Alaska Petrochemical Company Refinery and
Petrochemical Facility, Valdez, Alaska

EPA-10-AK-Valdez-NPDES-79
April 1980
EPA 910/9-79-064

Environmental Impact Statement

FINAL ENVIRONMENTAL IMPACT STATEMENT

TYPICAL PIPELINE CONFIGURATIONS (REVISED) Figure 3.3-5

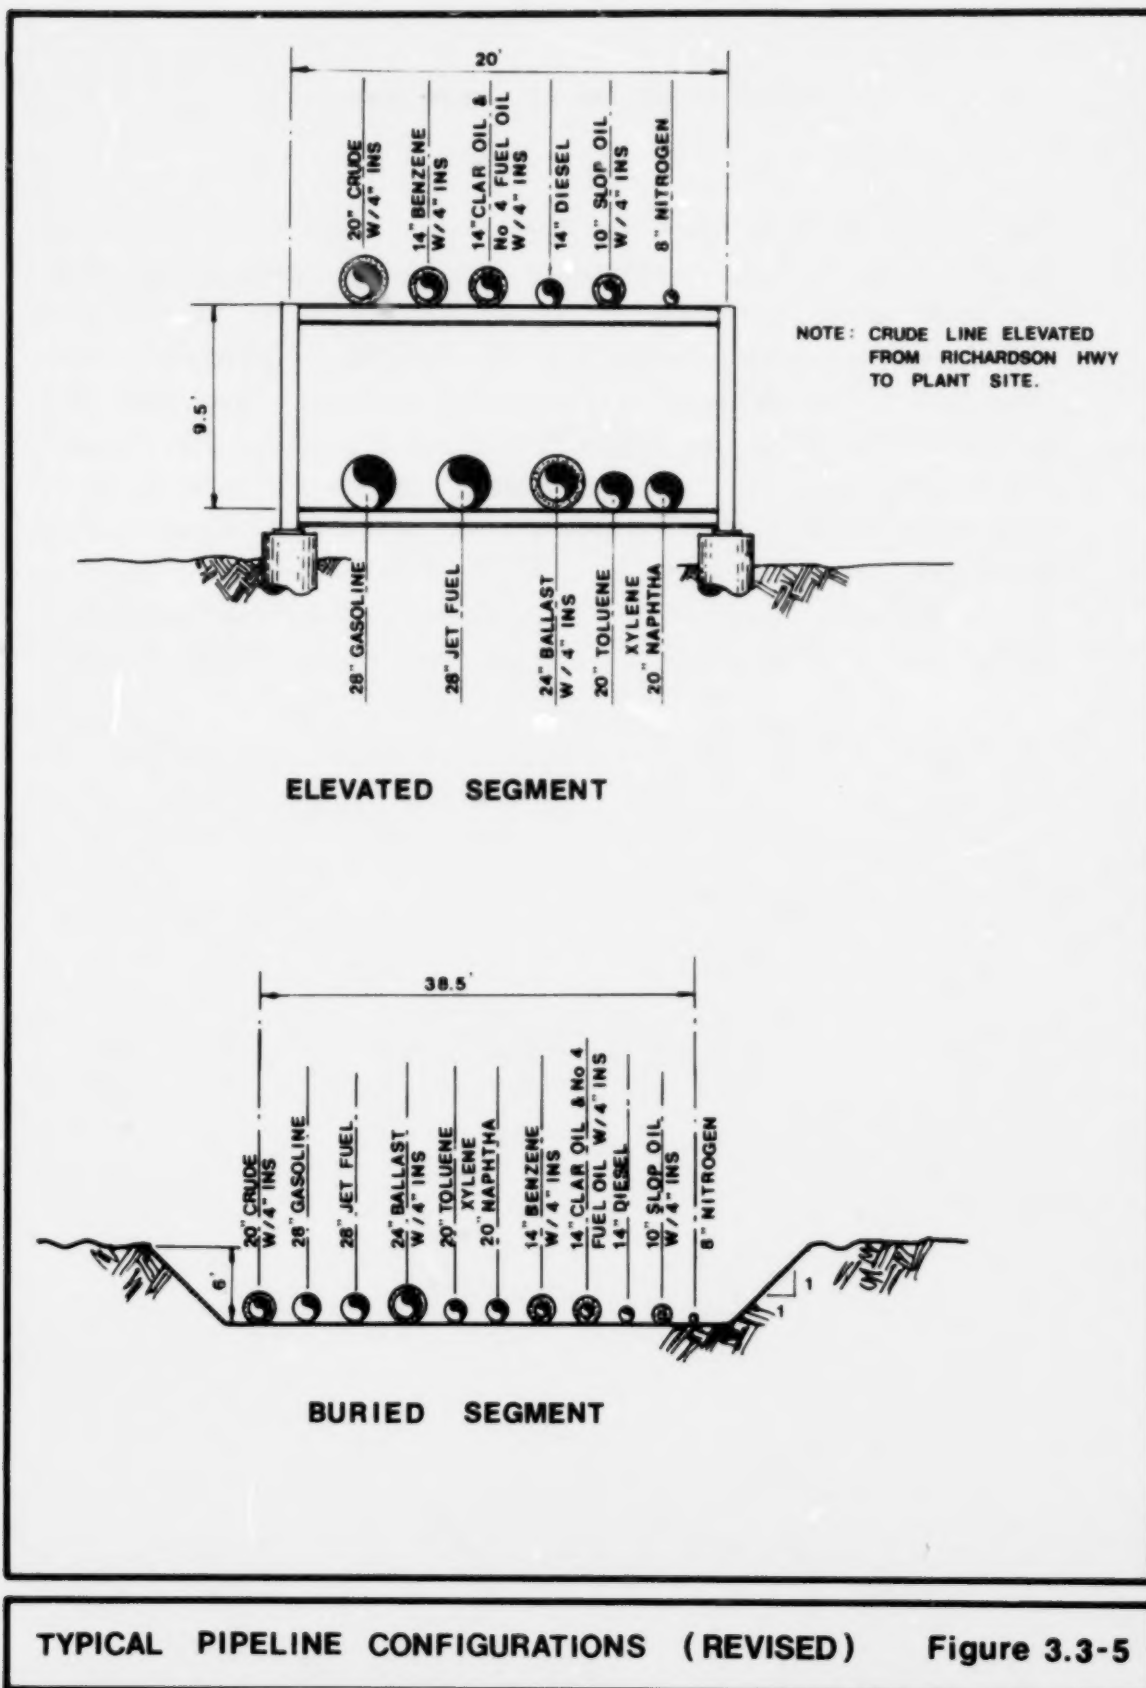
- C10 Present plans call for burying the products pipelines in wetland areas. Since leakage from buried pipelines is particularly difficult to detect and control and could cause major pollution of the groundwater system, strong consideration should be given to elevating the pipeline in vulnerable areas.

- C12 Comment #6 on page 4 of the letter concerning a buried pipeline crossing of Robe River not being justified, given the fisheries sensitivity of this stream.

There would be 10 products pipelines and one crude supply line which would be constructed in a combination of buried and above ground modes. The crude supply line from the Alyeska Pipeline to the Dayville Road and the entire pipeline bundle from the Richardson Highway in a westerly direction to the point of departure from Dayville Road would be a buried configuration. The remaining sections of pipeline from the proposed plant site to the Richardson Highway and from the point of departure from Dayville Road to the products dock would be constructed above ground on a two-level structure (see Figure 3.3-5 Revised). Approximately half of the length of the pipeline would be constructed in a buried mode and the remaining half in the elevated configuration.

- R10 See FEIS Section II, p. 13-16. The configuration of the pipelines in these areas has been revised to provide for elevated construction.
- C11 Comment #5 on page 4 of the letter concerning scheduling construction activities in anadromous fish streams for noncritical periods.

- R12 See FEIS Section II, p. 9 and 15. The pipeline configuration in this area has been modified to an elevated crossing, per the recommendation.
- C13 In addition to avoidance of construction impacts, the pipeline should be routed a sufficient distance away from bald eagle nests to preclude disturbance from pipeline surveillance vehicles and activities during the operation of the pipeline.
